# SERVICE BULLETIN

BULLETIN NO. 5

EQUIPMENT TYPE: TRANSMITTER 32S-3

SUBJECT: IMPROVEMENT IN VOX CIRCUIT TO ELIMINATE INTERMITTENT DROPOUT

32S-3 Chassis. Partial View Showing Location of Components Affected by this Modification.

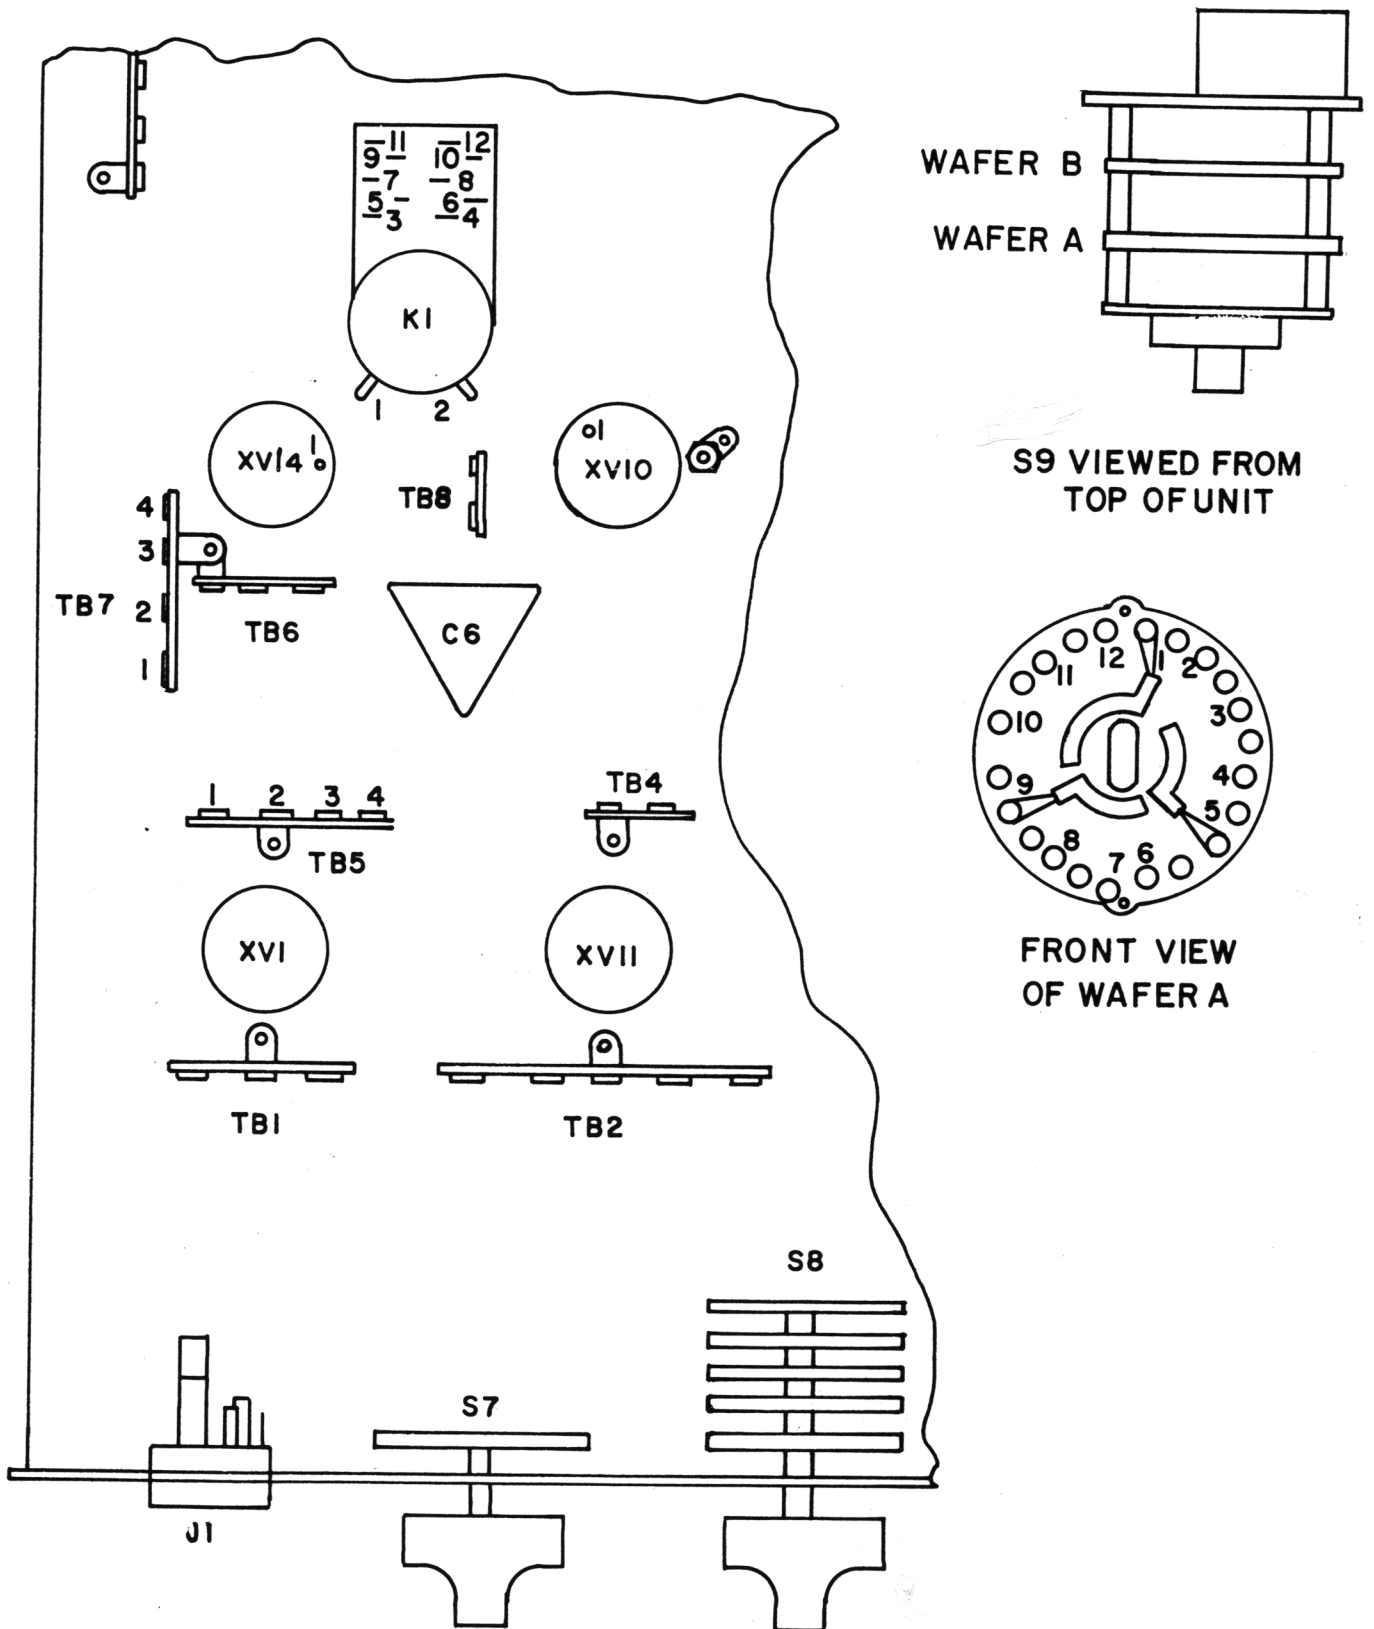
The modification in this service bulletin is to improve the vox circuit to eliminate intermittent dropout of the vox relay that may occur in some units during normal SSB transmission. This modification alters the VOX/ANTI-VOX circuit gain and changes associated time constants to make this improvement in vox operation.

2. Substitute a 0.02-uf capacitor (913-2142-00) for 0.1-uf capacitor C119. C119 is located between pin 5 of XV10 and terminal 11 of K1.
3. Install 0.1-uf capacitor C186 (913-3152-00) between pins 5 and 7 of XV10.
4. Install 20-uf capacitor C184 (183-1165-00) between pin 8 of XV14 and terminal 3 of TB7. Positive (+) lead should go to pin 8 and negative (-) lead to terminal 3.

5. Install 20-uf capacitor C185 (183-1165-00) between pin 3 of XV14 and terminal 2 of TB5. Positive (+) lead should go to pin 3 and negative (-) lead to terminal 2.
6. Turn transmitter right side up and jumper no. 22 AWG bus wire (421-2220-00) between terminals 10 and 11 of switch S9F. S9 is the FREQ CONTROL switch in the upper left corner of the front panel; S9F consists of terminals 9, 10, 11, and 12 of wafer A.
7. Install 20-uf capacitor C183 (183-1165-00) between terminal 10 of S9F and nearby grounding lug on front panel.
8. Replace transmitter chassis in cabinet and return to operation.
